TMPR3927 Specification Update

Revision History

TMPR3927F, TMPR3927AF, TMPR3927BF, TMPR3927CF

Figure 1 Unnecessary assertion of the STOP* signal

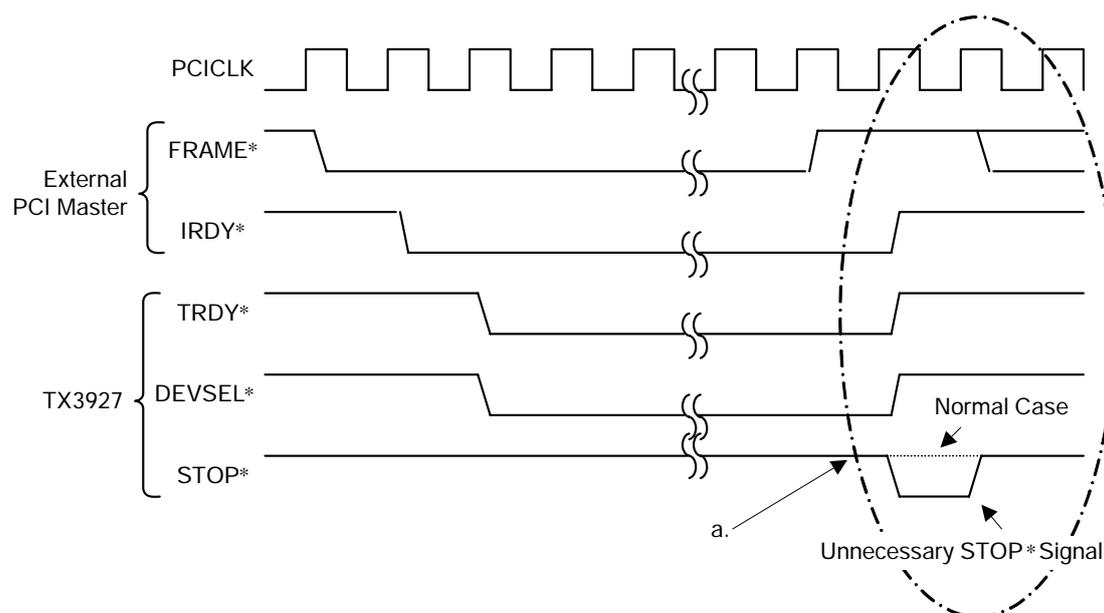
As shown in Figure 1 below, the PCI Controller in the TX3927 may, under particular conditions, assert the STOP* signal unnecessarily exactly when the PCI bus is idle. The external PCI master may be affected by this STOP* signal.

When the TX3927 PCI Controller is operating in Target mode and an external PCI master is bursting to the TX3927, the TX3927 PCI Controller asserts the STOP* signal unnecessarily when the completion of the burst cycle (a in the above figure) coincides with particular conditions of the TX3927.

There are the following three conditions:

- 1) When all of the following conditions a) to c) are true:
 - a) Bit 3, or the OFIFO 8-Clock Rule Enable (OF8E) bit, in the Target Control (TC) register (at 0xFFFFE_D090) of the PCI Controller is cleared.
 - b) The current burst cycle is a read.
 - c) The OFIFO becomes empty immediately before point a. in the above figure.

- 2) When all of the following conditions a) to c) are true:
 - a) Bit 4, or the IFIFO 8-Clock Rule Enable (IF8E) bit, in the Target Control (TC) register of the PCI Controller is cleared.
 - b) The current burst cycle is a write.
 - c) The IFIFO becomes full immediately before point a. in the above figure.

- 3) When all of the following conditions a) to c) are true:
 - a) Bit 11, or the PCI Snoop (PSBP) bit, in the Chip Configuration (CCFG) register at 0xFFFFE_E000 is cleared.
 - b) The current burst cycle is a write.
 - c) The CPU core requests bus mastership at point a. in the above figure while another bus master on an internal bus is executing a bus cycle.

Burst reads and burst writes require separate workarounds. If both burst reads and burst writes are performed, use both of the following workarounds.

- 1) When the burst cycle is a read
Set the OF8E bit in the Target Control (TC) register of the PCI Controller.

- 2) When the burst cycle is a write
 - a) Set the IF8E bit in the Target Control (TC) register of the PCI Controller.
 - b) Set the PSNP bit in the Chip Configuration (CCFG) register. In this case, however, it is prohibited to use the data cache in Write-back mode.

SDRAMC and ROMC AC Characteristics

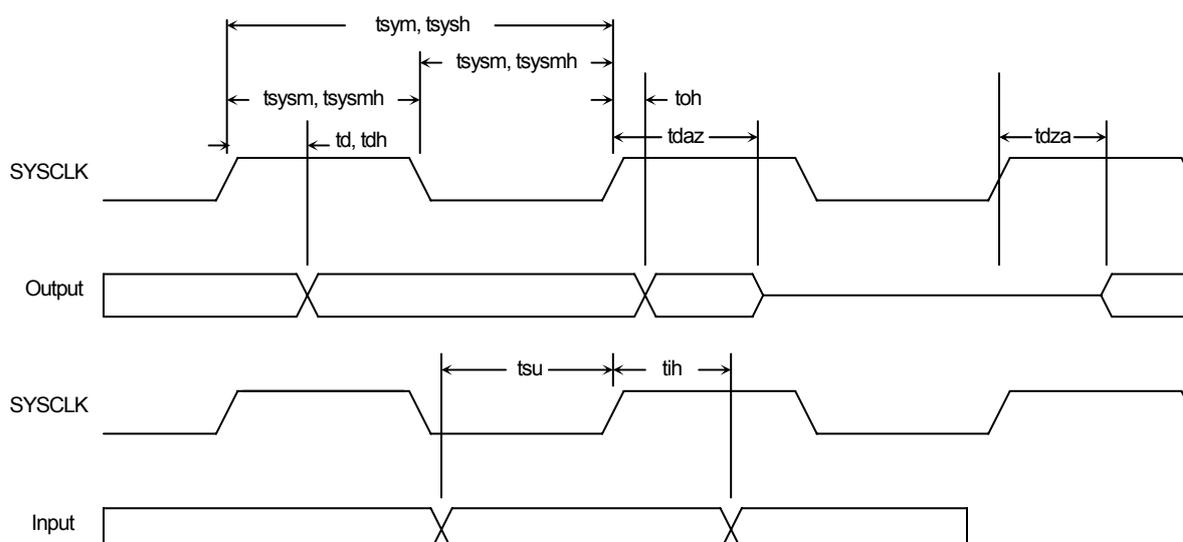
Difference

The Output Delay is defined separately for Full-Speed (t_d) and Half-Speed (t_{dh}) modes.

In Half-Speed mode, the specs of ADDR, ACE*, CE*, OE* and BE* differ from those of the other signals.

- 2) When more than one ROM Controller channel is used in Half-Speed mode, design a system, based on the AC specification shown on the following page.
- 3) Use the ROM Controller only in Full-Speed mode.

Workaround Examples

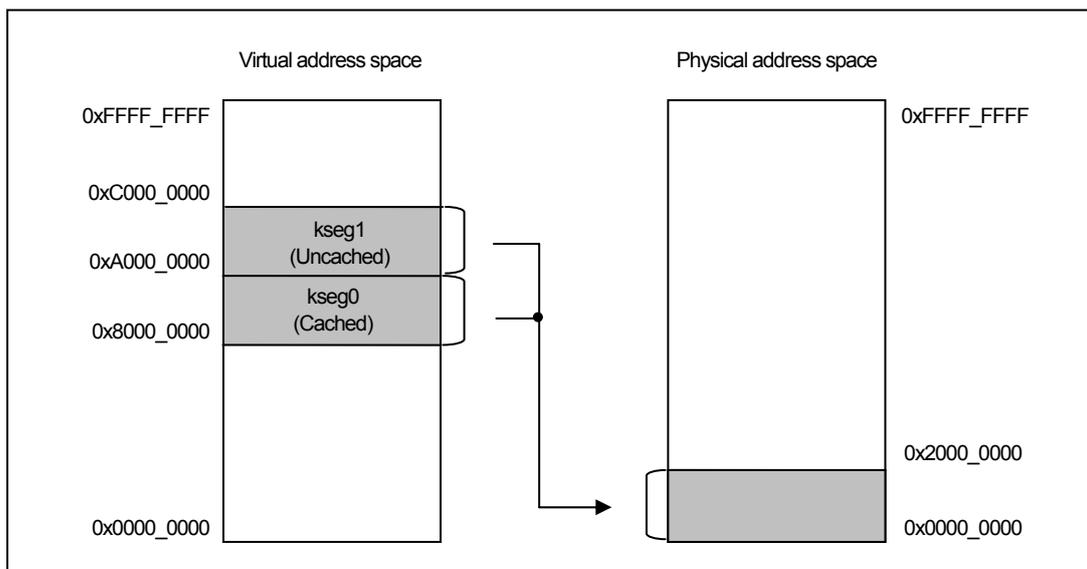
Here are examples of workaround 2 described above. In these examples, the cache is flushed without using the CACHE instruction.

< Example 1 >

0x8000_0000–0x9FFF_FFFF and 0xA000_0000–0xBFFF_FFFF in the virtual address space are mapped to the same range in the physical address space (0x0000_0000–0x1FFF_FFFF).

0x8000_0000–0x9FFF_FFFF is a cached area whereas 0xA000_0000–0xBFFF_FFFF is an uncached area.

Consequently, reading data from a cached area and writing that data to an uncached area whose physical address is the same as the read address has an effect equivalent to flushing the data cache with the CACHE instruction.

For example, if the data address that is the target of cache flushing is 0x8000_0000, perform the following steps:

- 1) Read out data from 0x8000_0000.
Because 0x8000_0000–0x9FFF_FFFF is a cached area, a read request is first issued to the data cache. Thus, when address 0x8000_0000 hits in the data cache, data is read from it. In the case of a cache miss, data is read from main memory (physical address 0x0000_0000).
- 2) Write the data that was read in step 1) to 0xA000_0000.
Because 0xA000_0000–0xBFFF_FFFF is an uncached area, data is always written to main memory (physical address 0x0000_0000).
- 3) Invalidate the data cache line containing data whose address is the same as that of step 1). This can be done with the CACHE instruction with the op field (bits 20:16) of 0x11.

Outline and Symptom

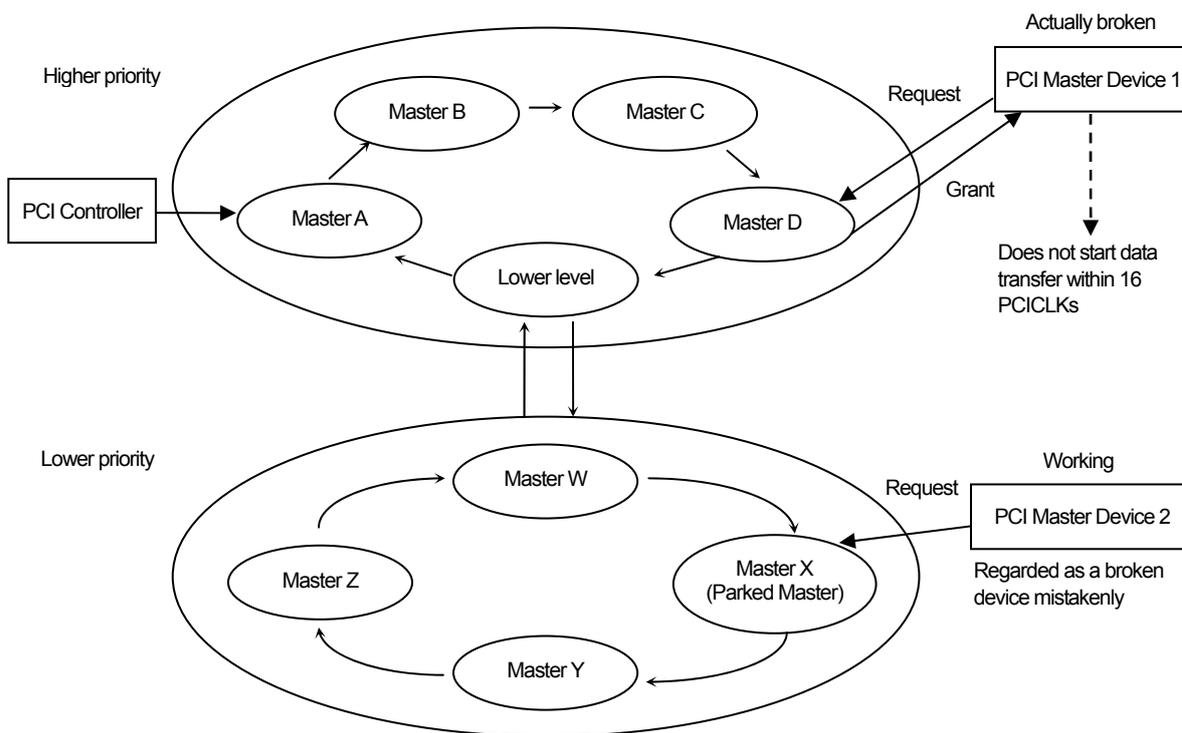
If you enable the PCI broken master checking feature, a working master device may be regarded as a broken master device and detached from the PCI bus arbiter.

- * The broken master checking feature of the PCI Controller identifies a PCI master that does not start a bus access even when it has gained bus mastership. It is treated as broken and excluded from the bus arbitration process.

When a given bus master is treated as broken, another PCI master might be treated as broken at the same time.
